**RE: MW-138D FLUTE™ LINER INSTALLATION AND MW-82D WELL INSTALLATION
WORK PLAN APPROVAL AND INFORMATION REQUEST**

Case No. 2006-0303-BA

Former Exxon R/S No. 2-8077

14258 Jarrettsville Pike, Phoenix

NEW WELL MAP

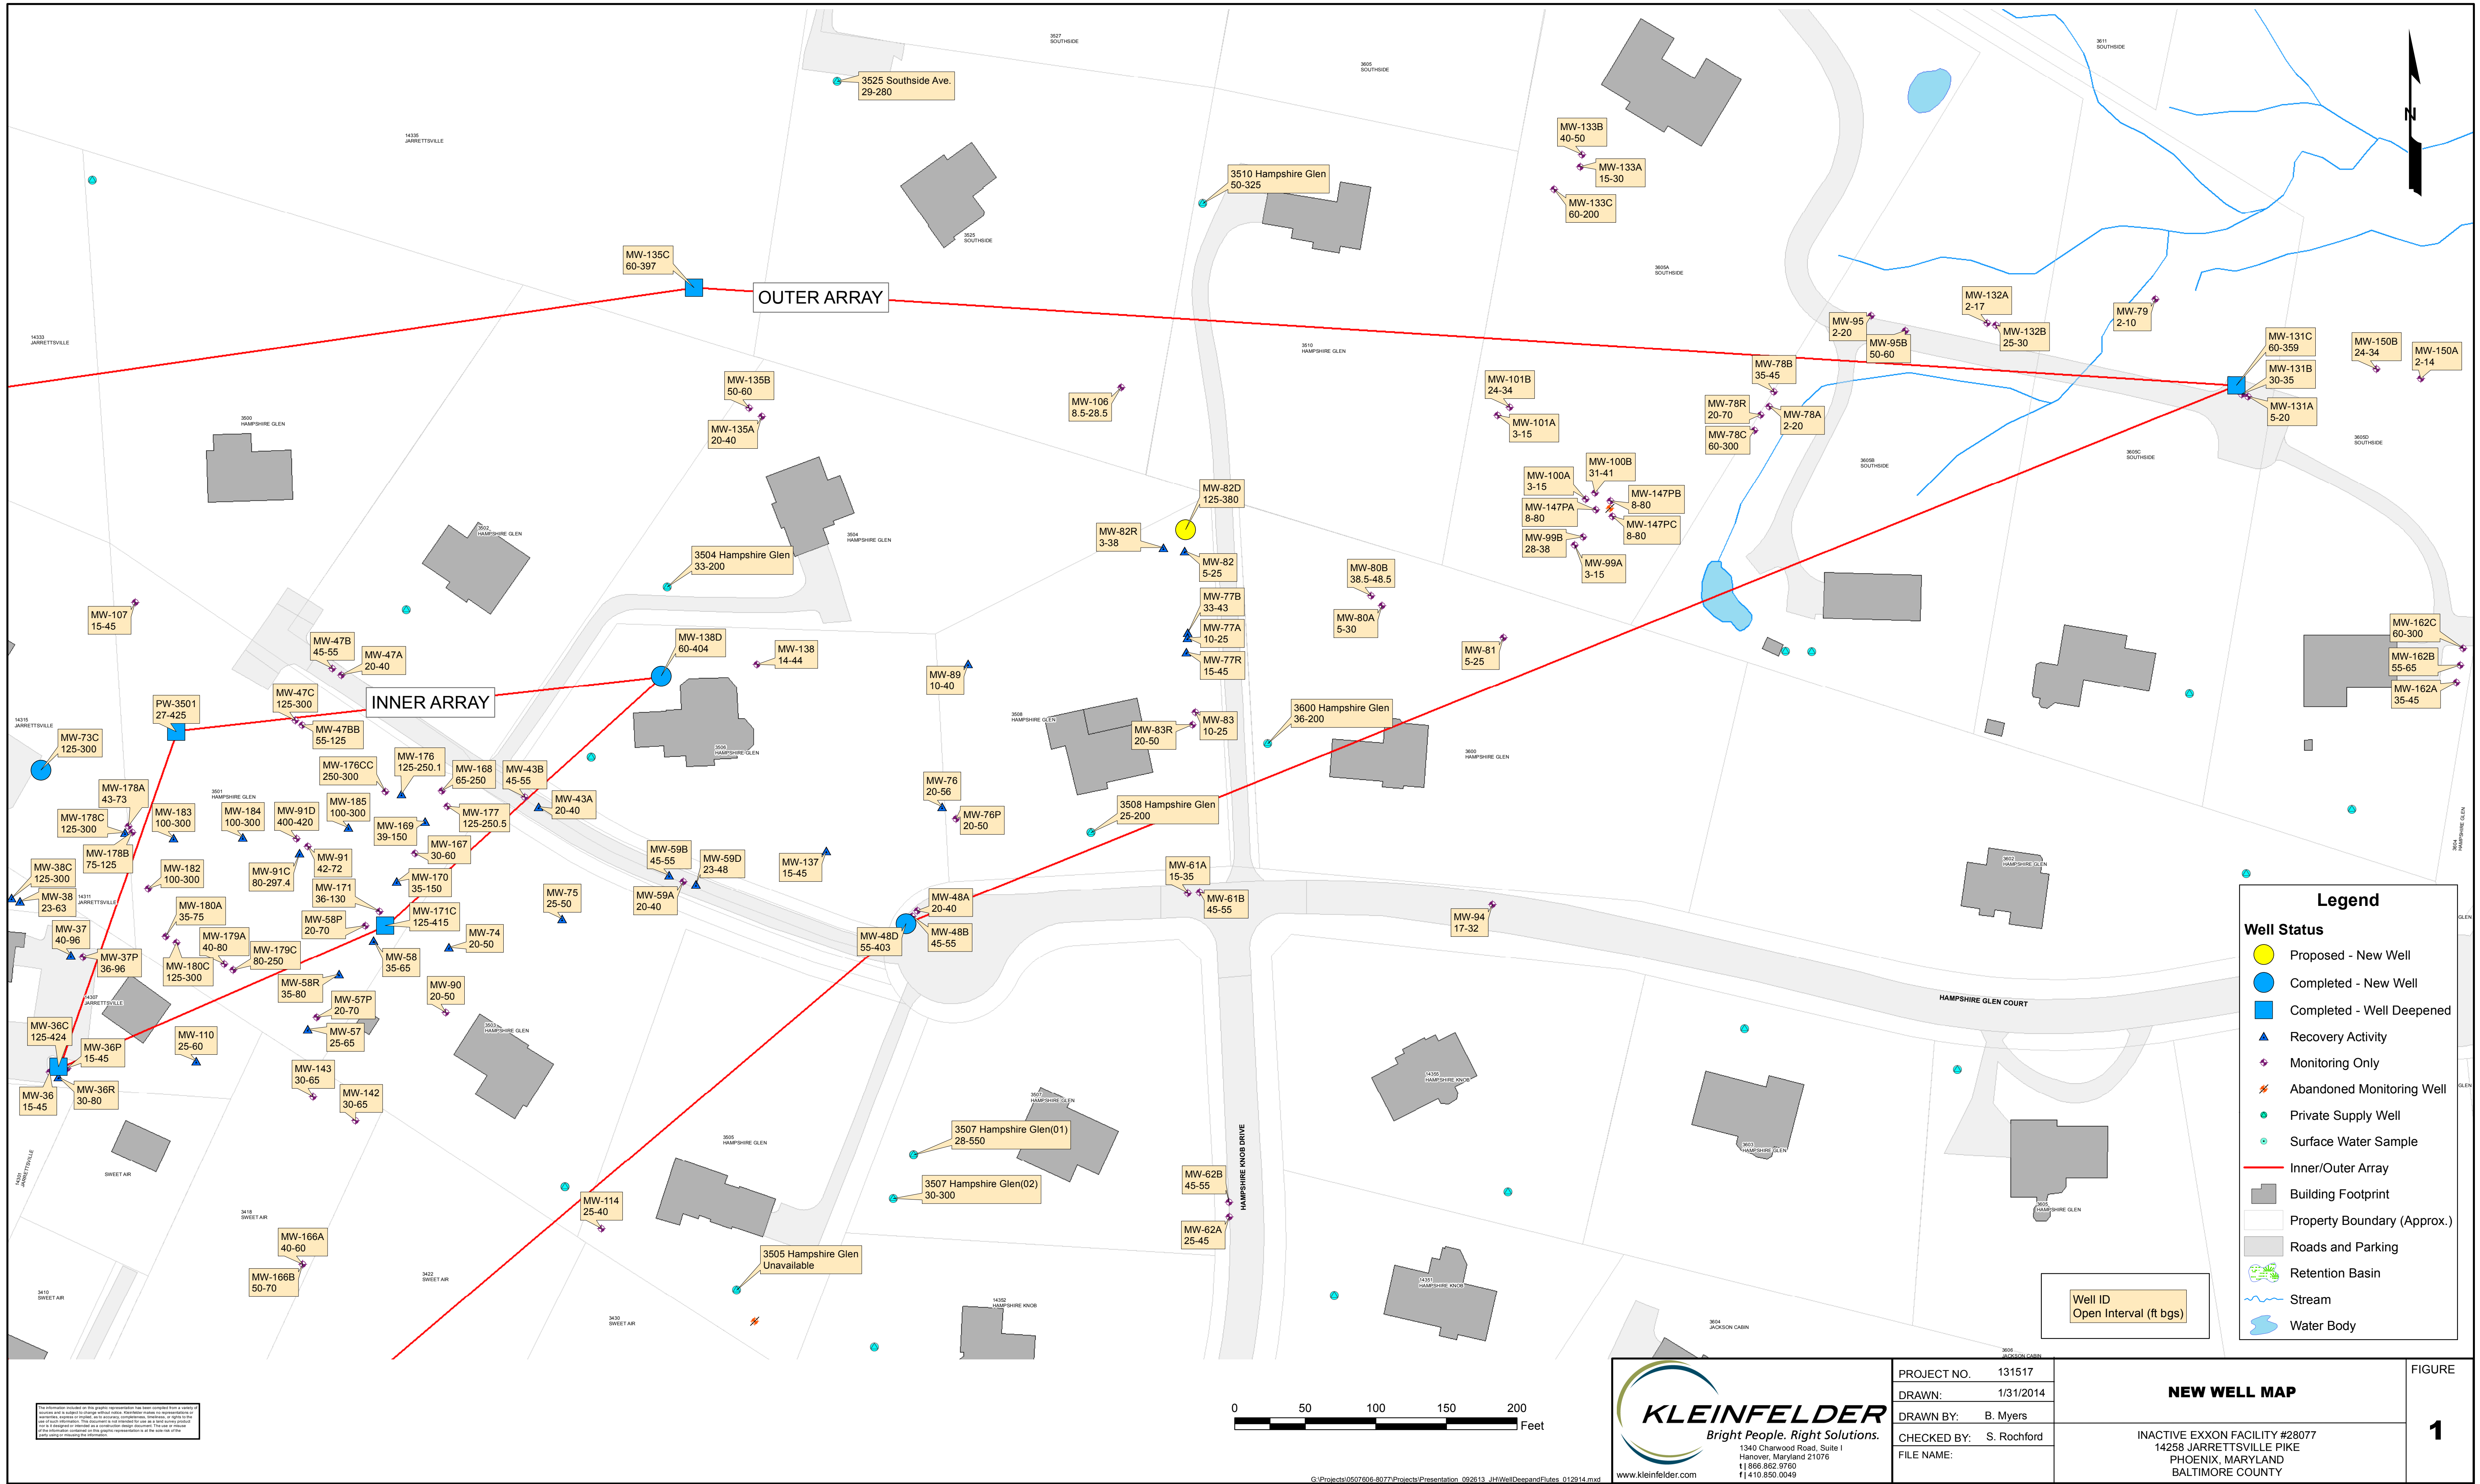
- 1- On the map showing the location of MW-82D, all the monitoring well shown on the figure must be identified with the well numbers in addition to noting the open borehole intervals for each well. This also includes showing locations of nearby domestic wells with their borehole open interval information, if known. Property addresses should also be included on the map.
- 2) As indicated on page 4 regarding the depth of proposed well MW-82 D; the table must include depths of the surrounding potable wells and open borehole depths to demonstrate that the proposed depth of 380-feet is appropriate as proposed.

1- On the map showing the location of MW-82D, all the monitoring well shown on the figure must be identified with the well numbers in addition to noting the open borehole intervals for each well. This also includes showing locations of nearby domestic wells with their borehole open interval information, if known. Property addresses should also be included on the map.

1. A revised Figure 1 showing property addresses as well as monitoring well IDs and open borehole intervals for monitoring wells and private supply wells in the area surrounding the proposed location of MW-82D;
2. An expanded table including the total depth and open borehole intervals for potable wells surrounding the proposed location of MW-82D.
